Proposed Technical Specification Amendment No. 1B2, Revision 2  
Permanently Defueled Technical Specification  
Appendix C to Facility Operating License No. DPR-54

APPENDIX C  
TO  
FACILITY OPERATING LICENSE NO. DPR-54  
TECHNICAL SPECIFICATIONS  
FOR THE  
DEFUELED RANCHO SECO FACILITY

RANCHO SECO UNIT 1  
PERMANENTLY DEFUELED  
TECHNICAL SPECIFICATIONS

FIGURE D5.1-2

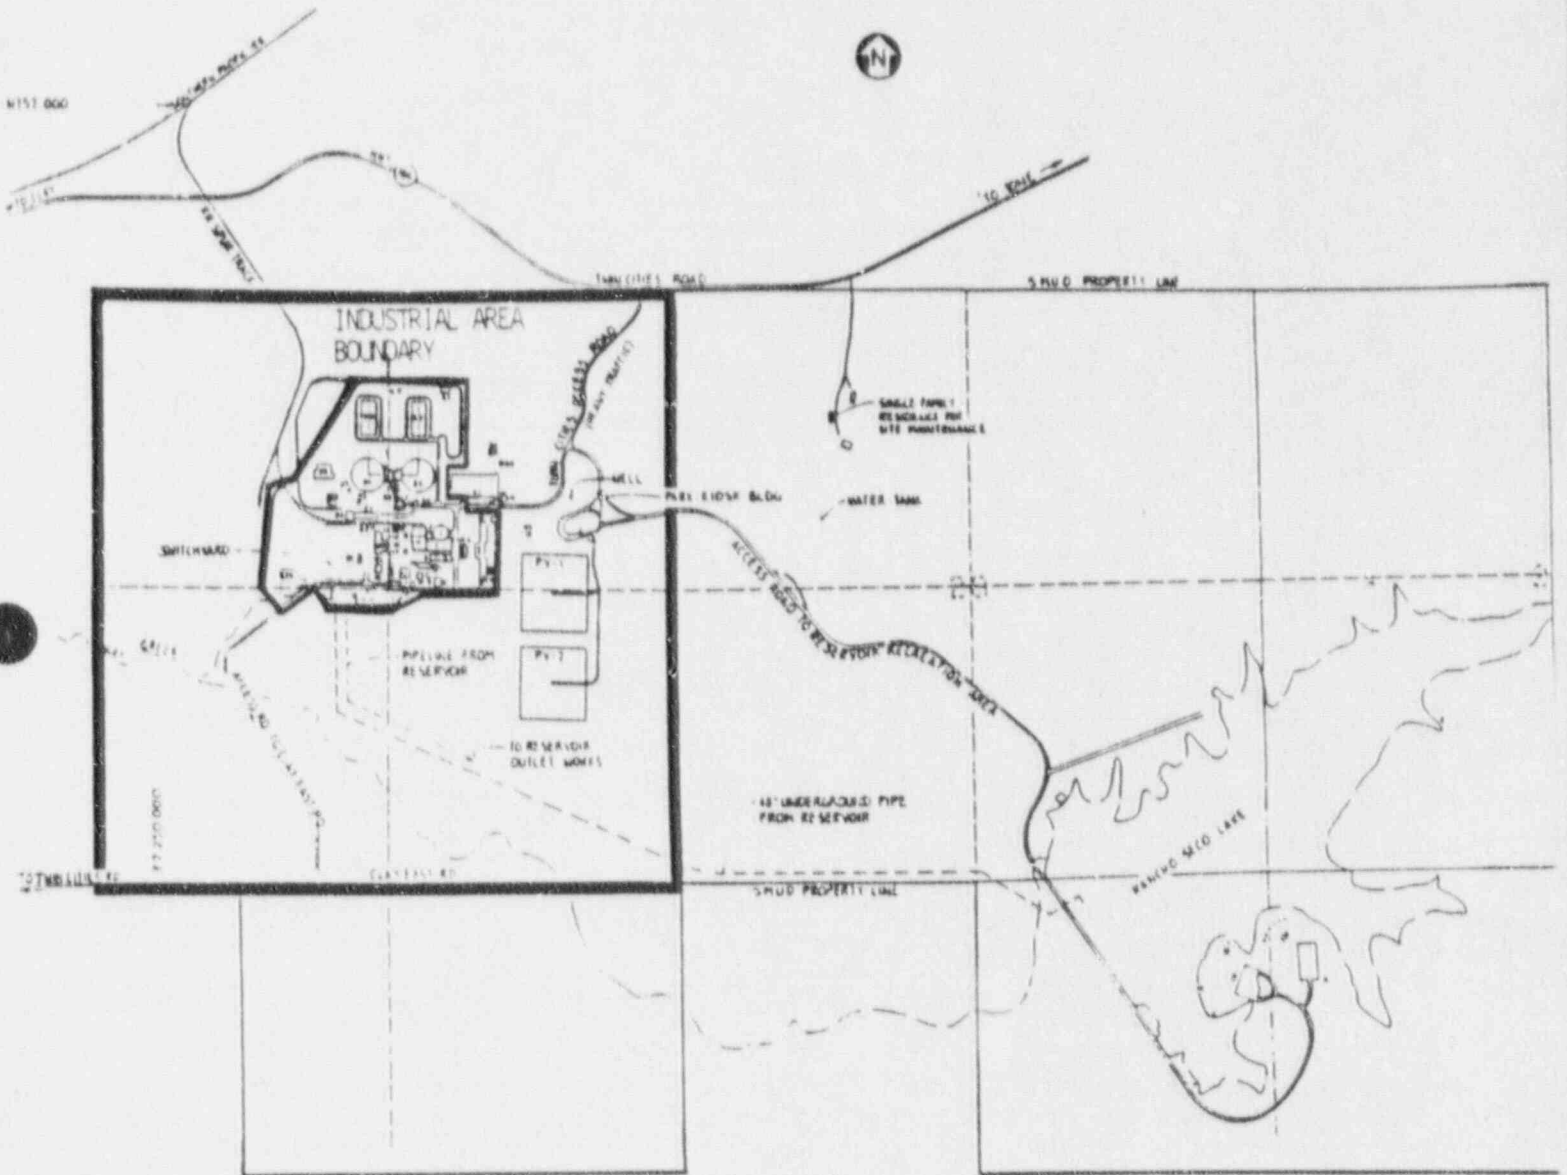
- 3.18.1 The Site Boundary for Gaseous Effluents (PDS Figure D5.1-2) will be used in lieu of the Exclusion Area currently used for evaluating the dose rate limits of Specification 3.18.1. This change does not affect the current dose calculation methods specified in the ODCM for gaseous effluents, is consistent with the other gaseous effluent Technical Specifications (3.18.2, 3, and 4), and is consistent with NUREG-0133, Preparation Of Radiological Effluent Technical Specifications For Nuclear Power Plants. Specification 3.18.1 is relocated to the ODCM per Generic Letter 89-01.

The Site Boundary for Gaseous Effluent for 10 CFR 20 compliance and for meeting 10 CFR 50, Appendix I guidelines is shown in Figure D5.1-2.

FIGURE D5.1-3

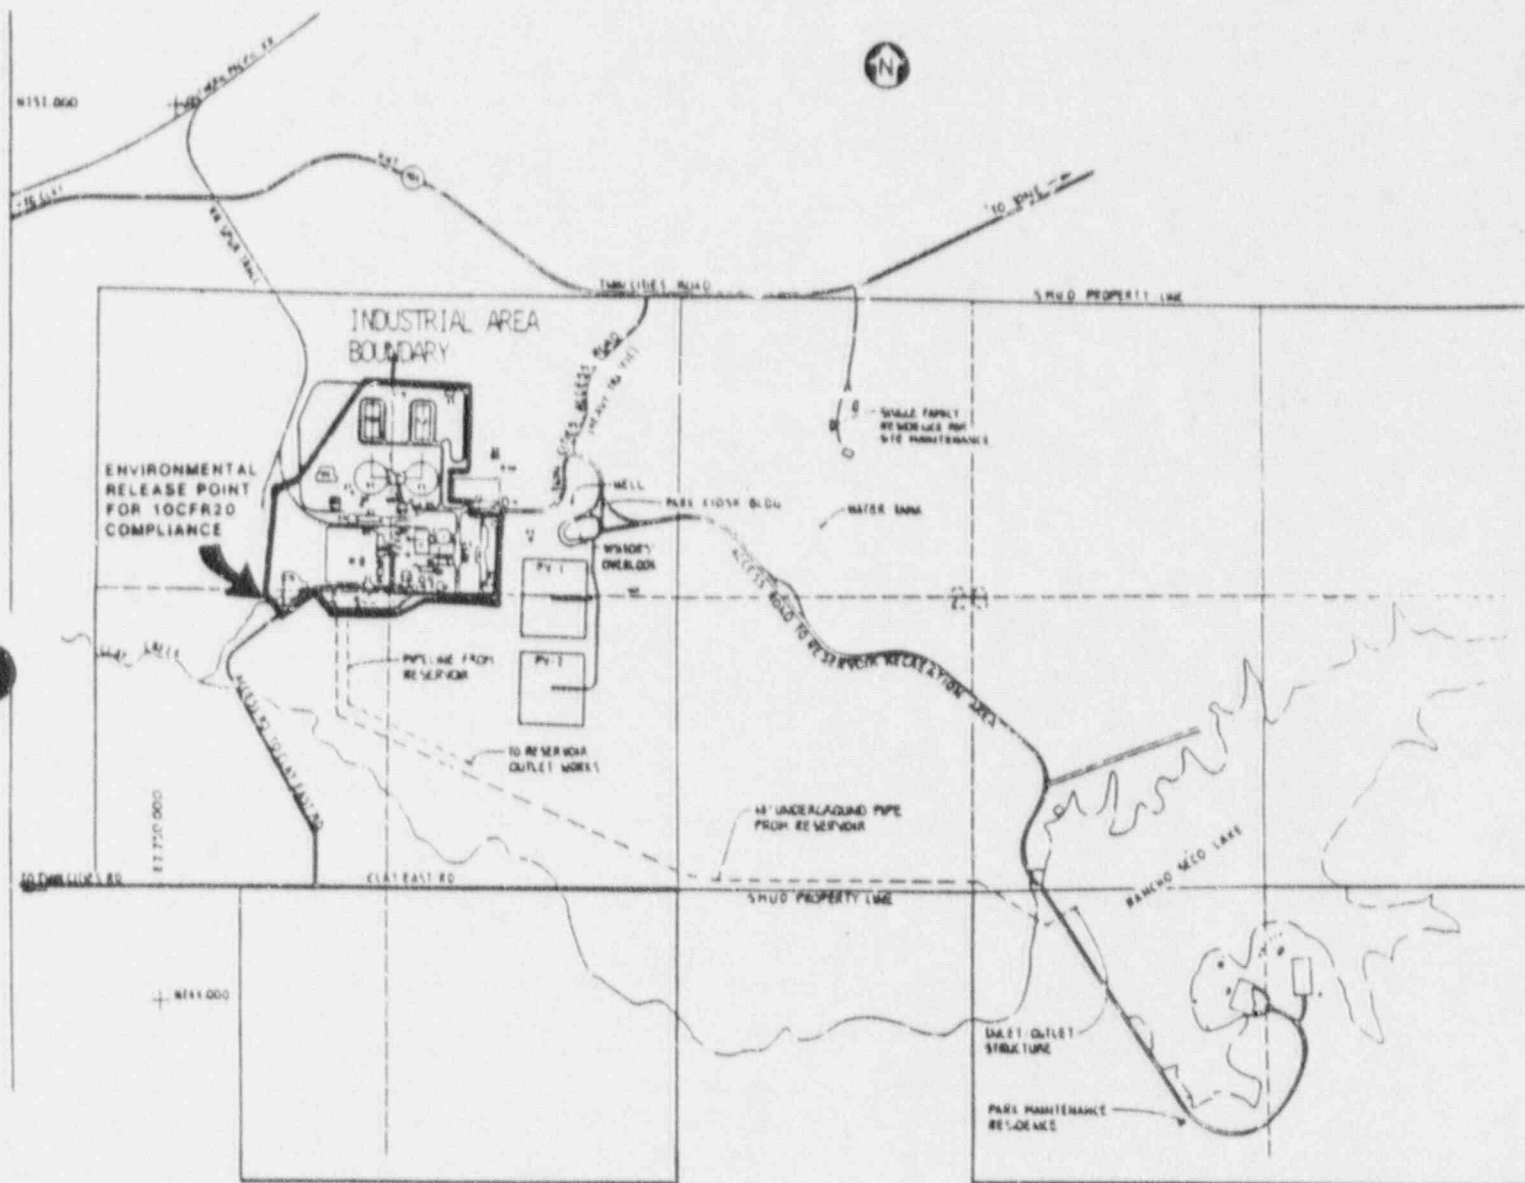
The titles of Figures 5.1-3 and 5.1-4 are modified in accordance with the Standard Radiological Effluent Technical Specifications (NUREG-0472) to clarify the application and significance of the two effluent boundaries. Also, the two figures are renumbered D5.1-2 and D5.1-3 and included in the PDS. The gaseous effluent boundary (PDS Figure D5.1-2) applies to gaseous effluents released from the site under normal conditions and is used to evaluate both 10 CFR 20 and 10 CFR 50, Appendix I compliance. The liquid effluent boundary (PDS Figure D5.1-3) identifies the boundary at which radiological liquid effluent actually leaves the Industrial Area. The dose accountability points for meeting the 10 CFR 50, Appendix I guidelines remains at the A and B Regenerant

- 5.1 (D5.1) (Con.) Hold-Up Tanks, and the concentration accountability points for determining 10 CFR 20, Appendix B compliance remains at the Retention Basins. Under accident conditions the EPZ boundary is used to evaluate the potential consequences of an accident and the corresponding response and notification actions required in accordance with the defueled condition Emergency Plan. The EPZ boundary is the same as the liquid effluent boundary, and more conservative than the gaseous effluent boundary.

The boundary for Liquid Effluent for 10 CFR 20 Compliance is shown in Figure D5.1-3. The dose accountability points for meeting the 10 CFR 50, Appendix I guidelines remains at the A and B Regenerant Hold-Up Tanks. Concentration accountability points for determining 10 CFR 20, Appendix B compliance remains at the Retention Basins.
